Comments from India

The comments on the proposed GTR for motorcycle brakes, based on the Document
“Appendix A :Regulation Comparison table “ of the Working paper “1-GTRBR-04”

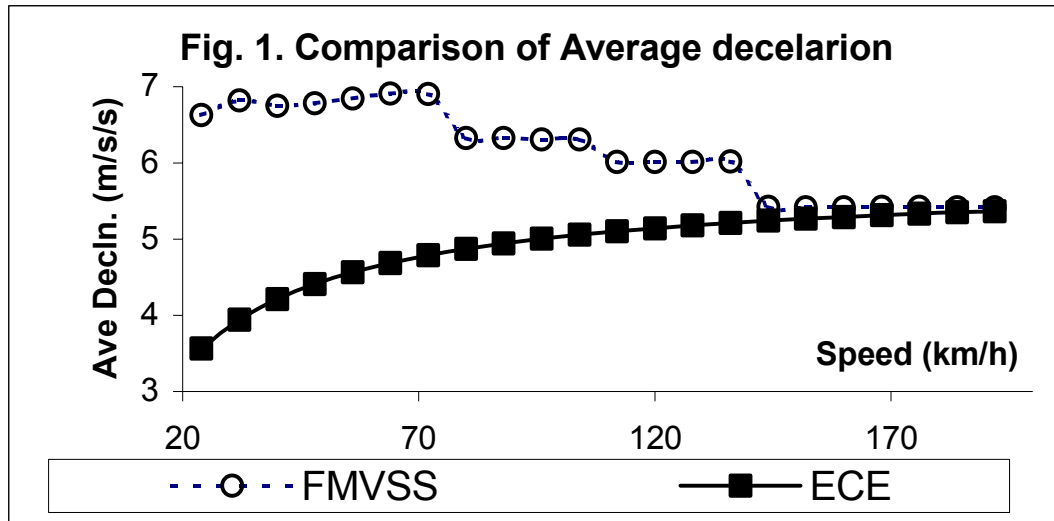
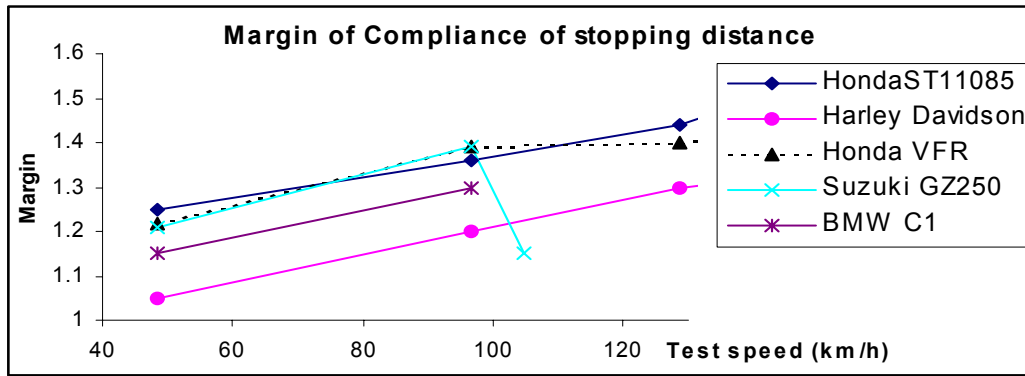
Item No. 3 of Appendix A-	Requirements:
	<p>a) Method of specifying the Stopping distance:</p> <p>Stopping distances are specified in:</p> <ul style="list-style-type: none"> • FMVSS 122 in a table form. • ECE R78 in the form of binomial equation of speed. <p>Annex A of the report summarised the ECE R78 procedure as “<i>Performance based on stopping distance, determined either by measruing the stopping distance or the mean fully developed deceleration</i>”.</p> <p>However, the para 1.1.1 of Annex 3 of R78 as amended vide Supplement 3 to the 02 series of amendments - Date of entry into force: 7 December 2002, reads as under,</p> <p><i>“The performance prescribed for braking devices shall be based on the stopping distance and/or the mean fully developed deceleration. The performance of a braking device shall be determined by measuring the stopping distance in relation to the initial speed of the vehicle and/or measuring the mean fully developed deceleration during the test.”</i></p> <p>Our understanding of this amendment is that, it is necessary to check both the stopping distance and MFDD for establishing compliance. We request the advice of the experts whether our understanding is right.</p> <p>We prefer ECE R78 method for the following reasons:</p> <ul style="list-style-type: none"> • As per the table prescribed in FMVSS, 122 the average deceleration requirements decrease with an increase in test speed. This is evident from Figure 1, which shows the comparisons of the average deceleration calculated from the stopping distance values specified in FMVSS 122 and ECE R78. Figure 2, based on the test results quoted in the Annex B of the report, also indicate that the margin of compliance is lower at low speeds. Specifying more stringent deceleration requirements at lower speeds is not logical. The only exception found was in the case Suzuki motorcycle. • ECE R78 method is based on a minimum requirement of MFDD, which is the actual design performance of the brake system, while prescribing a correction for the reaction time during the testing. • In the case of passenger cars, FMVSS 135 already specifies the method of binomial equation. • As most of the Indian two wheelers are the low speed type, it is desired that the brake design need not be made more stringent than that for high-speed motor cycles. • If MFDD is used, it should be based on the deceleration and averaging the area under the stabilised portion of the deceleration -time graph.

b) Load condition of the vehicle:

FMVSS 122 prescribes vehicle to be tested in a condition representing a single rider situation. No tests are prescribed for the GVW condition.

ECE R78 prescribes tests in GVW condition and also in the single rider situation. The stopping distance and MFDD requirements in the GVW condition are more stringent than those for the single rider condition.

In India, operation of two and three wheeler in the GVW condition is predominant. Therefore, we feel that the performance requirements should be specified in the GVW condition. As the single rider situation is also important, it is suggested that the practice of ECE R78 of having both the conditions be incorporated in the GTR.

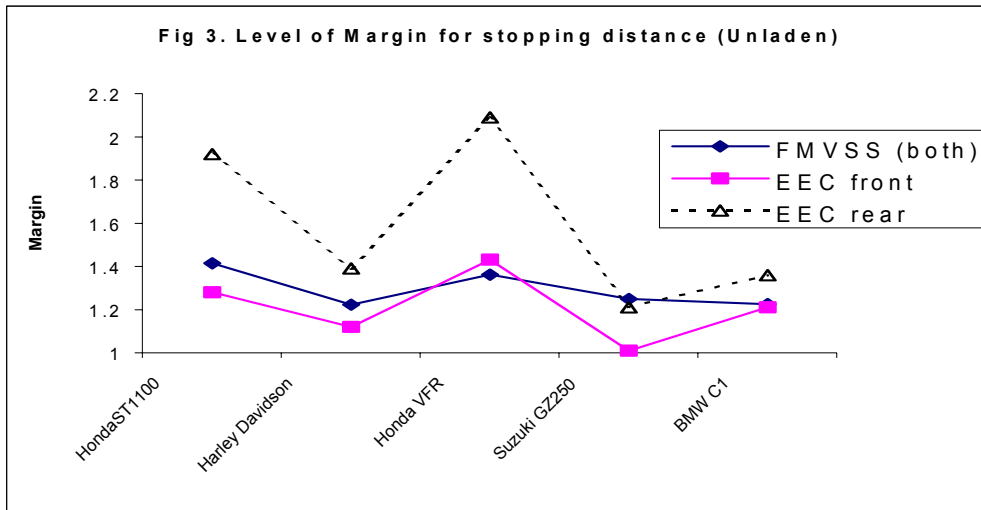
The margin of compliance on stopping distance for unladen tests from Appendix B is

plotted below in Figure 3:

The margin of compliance for front brake requirements of ECE R78 and both brakes for FVMSS are of the same order. The cases where a predominantly higher margin for the rear brake requirements of ECE R78 has been observed in the case of Honda VFR and HondaST1100, both of which have ABS and fairly large dry weight. It therefore appears logical to incorporate the ECE R78 requirements for the unladen conditions in the GTR. Though, we have no experience with ABS brakes for two and three wheelers, from the test results, it appears that a tighter norms can be laid down for rear brake on motorcycles with ABS, especially when the unladen weights are higher. The experts may like to review this.

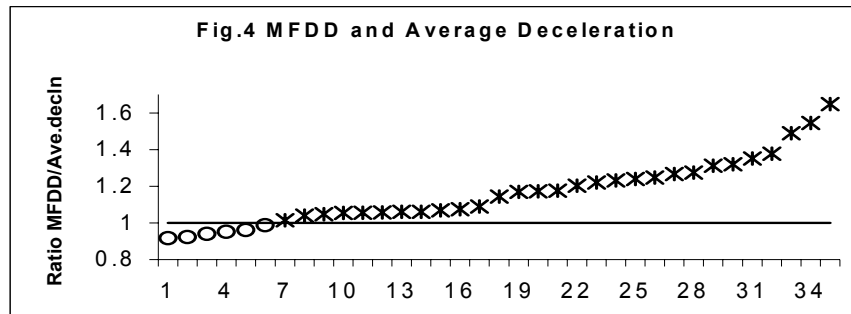
FMVSS 122 prescribes test to be conducted with both the brakes applied, whereas in ECE R78, the stress is on the individual brakes meeting the requirements. Testing both the brakes together is applicable only if the individual brake requirement can not be met due to lack of adhesion.

Brake tests with application of two controls simultaneously are likely to have more experimental variation and repeatability would be much less and India would prefer the ECE R78 practice.
